Subject: MHI's Response to US-APWR DCD RAI No.318

References: 1) "Request for Additional Information No. 318 Revision 1, SRP Section: 09.05.04 - Emergency Diesel Engine Fuel Oil Storage and Transfer System, Application Section: Tier 2 9.5.4," dated April, 6, 2009

Responses to Request for Additional Information No.318 Revision 1

US-APWR Design Certification

Figure 9.5.4-1 Gas Turbine Generator Fuel Oil Storage and Transfer System Schematic Diagram

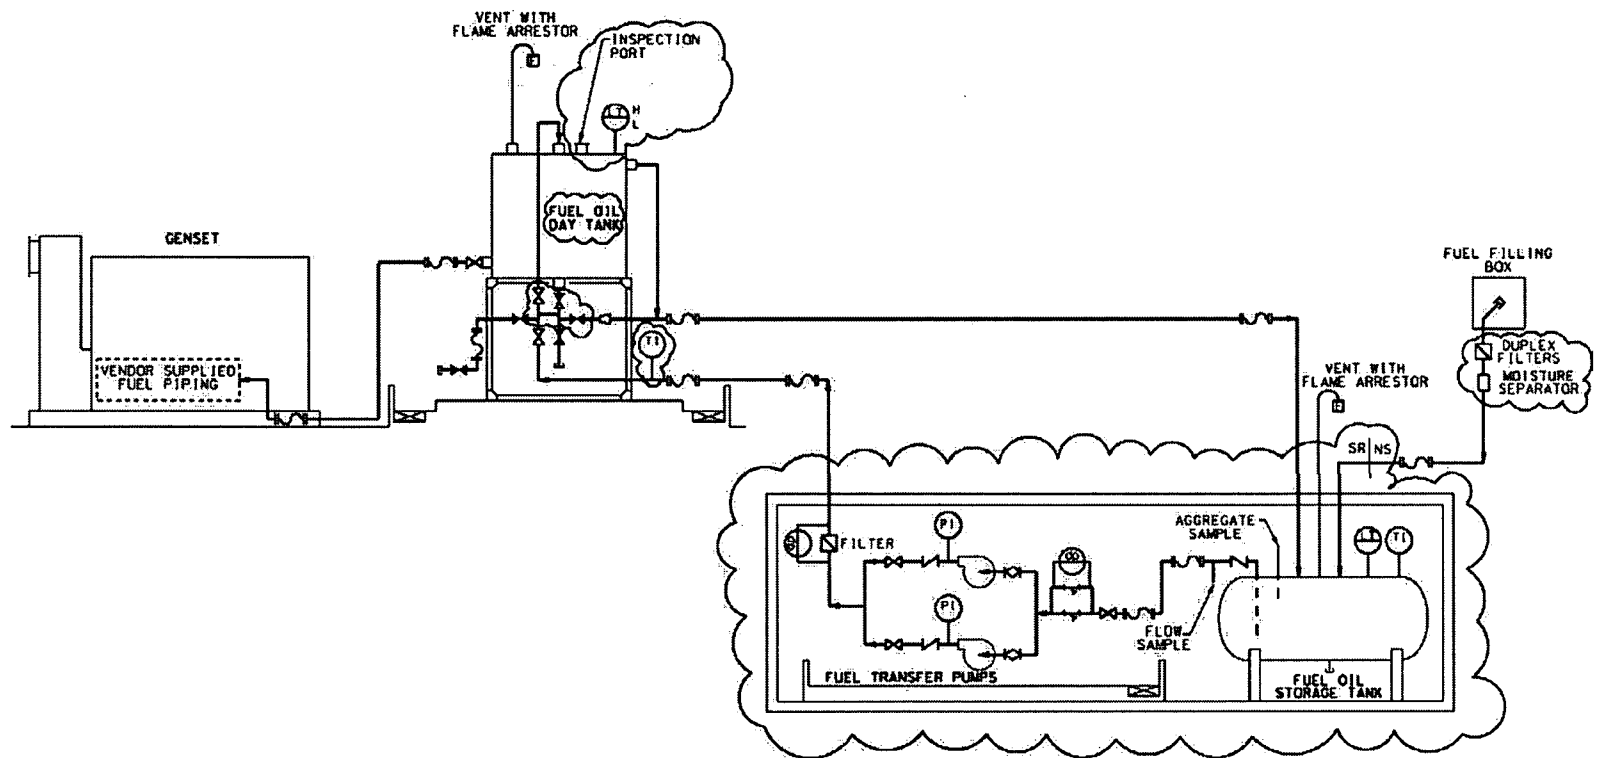
RAI 9.5.4-01: FSAR Tier 2 Table 9.5.4-1 states that the safety related portion of the system piping, fitting and valves will be ASME Section III. This implies that a portion of the system piping will be non-safety related. SRP 9.5.4 stipulates that the demarcation between safety-related and non-safety related piping be indicated on the system drawings. There is no indication of the boundaries on FSAR Tier 2 Figure 9.5.4-1. The applicant should revise Figure 9.5.4-1 to indicate the demarcation between safety and non-safety related portions of the system.

In accordance with ANSI/ANS 59.51-1997, there are provisions in the Fuel Oil Transfer System for both a flowing and a tank aggregate sample. The DCD will be revised to clarify that both these sample points exist. Figure 9.5.4-1 will be revised to show the connections for both of these sample points (flowing sample and tank aggregate sample).

For clarity, Figure 9.5.4-1 will be updated to show the drain connection coming from the bottom of the Fuel Oil Storage Tank, as shown in the attached markup.

RAI 9.5.4-17: Section 9.5.4.2.2.2 describes the fuel oil transfer pumps as components on modularized skids. FSAR Tier 2 Table 9.5.4-1 indicates that the fuel oil transfer pumps are designed to operate with a flooded suction. From Figure 9.5.4-1, it would appear that this transfer pump skid is at grade elevation and therefore above the tank. In order to ensure the GTGFSS design meets the availability requirements of GDC 17, staff needs information regarding available NPSH based on the design and on specified fuels. In addition, the applicant should specify a minimum NPSH required by the fuel oil transfer pumps. Available/required NPSH should be based on all pump design operating conditions, including pump runout.

RAI 9.5.4-19: FSAR Tier 2 Figure 9.5.4-1 indicates a containment curb around the fuel oil transfer pumps. If these pumps are located outdoors and uncovered, the applicant should provide a description of how rainwater accumulation will be monitored and removed to ensure that pump operation is not adversely impacted by the water.

RAI 9.5.4-20: The description of system filters and strainers in FSAR tier 2 Section 9.5.4.5 is unclear and inconsistent with Figure 9.5.4-1. This section describes instrumentation for “fuel oil transfer pump discharge strainers” and separately describes instrumentation for “the filter in the discharge line to the day tank”. These are the same lines – between the pump discharge and the day tank inlet – implying that there are both strainers and a filter in the line between the pump discharge and the day tank. In addition, neither the described filter nor the strainers are shown on Figure 9.5.4-1 or described in Table 9.5.4-1. The figure indicates only a single Y-type strainer in the transfer pump suction line. ANSI/ANS-59.51-1997 requires that two strainers be provided in a parallel arrangement that allows cleaning of a dirty strainer during engine operation. In addition, according to the “Qualification and Test Plan for Class 1E Gas Turbine Generator System,” December 2007(MUAP-07024-P(R0)), Section C.2.2.6.4, a filter is provided between the day tank and the engine driven pump. Figure 9.5.4-1 does not show this filter. The applicant should resolve these inconsistencies, provide design information on the strainers/filters and revise the FSAR accordingly.

RAI 9.5.4-21: Section 5.5.4 of ANSI/ANS-59.51-1997 requires that filters be provided in the fill line to each fuel oil storage tank. FSAR Tier 2 Figure 9.5.4-1 does not show this filter and the system description in FSAR Tier 2 Section 9.5.4.2.4 states that a strainer is provided in the fill line. In addition, Figure A1 of the standard, while not considered a part of the standard, does provide a level of detail that reflects the design requirements of the standard and this level of detail should be used as the basis for Figure 9.5.4-1 of the FSAR. The applicant should fully and specifically address the requirements of the ANSI/ANS standard and to revise Figure 9.5.4-1 to provide a level of detail similar to that in Figure A1 of the standard and reflect the design commitments included in FSAR Tier 2 Section 9.5.4.

RAI 9.5.4-22: FSAR Tier 2 Section 9.5.4.2.4 states that part of the fuel oil transfer pump discharge is returned to the fuel oil storage tank via the recirculation line. The piping configuration shown on FSAR Tier 2 Figure 9.5.4-1 will not allow this function. The only path for recirculation to the storage tank is via the overflow from the day tank or by aligning the normally closed valves in the day tank drain line. The overflow is not an acceptable means to continuously return flow to the storage tank. The day tank drain line is shown on the figure with normally closed valves. The applicant should describe how the continuous recirculation function will work and show the piping for this function on Figure 9.5.4-1.

The safety-related boundary occurs on the line from the fuel fill connection. Figure 9.5.4-1 will be revised to show this boundary.

Figure 9.5.4-1 will be revised as shown in the attached markup.

See attached markup for revision to Figure 9.5.4-1.

See attached markup for revision to Figure 9.5.4-1 to include the temperature instrumentation.

Figure 9.5.4-1 is a sketch, not meant to show the actual elevations of the equipment, however this figure is being revised for clarity as shown in the attached drawing. As addressed in RAI No. 09.05.04-08, these pumps are located in the storage tank vault, below the tank outlet, and are therefore able to operate with flooded suction.

The fuel oil transfer pumps are located in the fuel oil storage tanks vaults, as shown in the updated Figure 9.5.4-1, such that sufficient net positive suction head is available under all design conditions, including pump runout. The available NPSH is calculated based on all pump design operating conditions and is incorporated as part of the oil transfer pumps specifications to provide assurance from the pump vendor to properly design and fabricate the oil transfer pumps for their intended purpose. Once a vendor has been selected, the specific parameters for the pumps, including available NPSH, will be confirmed based on vendor documents.

Figure 9.5.4-1 will be updated as shown in the attached markup.

The correct equipment description should state that there is a filter between the pump discharge and the day tank. The strainers and associated instrumentation described in Section 9.5.4.5 are on the fuel oil transfer pump suction. The description in Section 9.5.4.5 will be updated to reflect the correct design. Also, the filter between the pump discharge and the day tank will be added to Figure 9.5.4-1.

The strainers on the suction side of the fuel oil transfer pumps are part of the fuel oil transfer skid. There are two of these strainers, arranged in parallel. Figure 9.5.4-1 will be updated to show the correct arrangement of these strainers.

Also, Figure 9.5.4-1 will be revised as shown in the attached markup.

The requirements of ANSI/ANS-59.51-1997 are fully and specifically addressed in Question No. 09.05.04-10 (RAI 9.5.4-05) response. Figure 9.5.4-1 will be revised to include the filters in the fill line to each fuel oil storage tank to provide a level of detail similar to that in Figure A1 of ANSI/ANS-59.51-1997. DCD Section 9.5.4.2.4 will be revised to state that a filter not a strainer is provided in the fill line.

Figure 9.5.4-1 will be revised as shown in the attached markup.

The overflow is not intended to be used to continuously return flow to the storage tank. Recirculation is provided by appropriately lining up the recirculation valves in the open position to allow for periodic recirculation and filtration of the fuel oil inventory when the sampling and testing program shows a need to reduce entrained particulate matter. During the fuel oil day tank filling mode, part of the pump discharge do not need to be returned to the fuel oil storage tank. DCD Section 9.5.4.2.4 will be revised accordingly. Figure 9.5.4-1 will be revised to show the appropriate valves normally open during fuel oil day tank filling mode.

Figure 9.5.4-1 will be revised as shown in the attached markup.

Refer to question no. 09.05.04-20, RAI 9.5.4-15, which has revised Figure 9.5.4-1 to include this instrumentation.
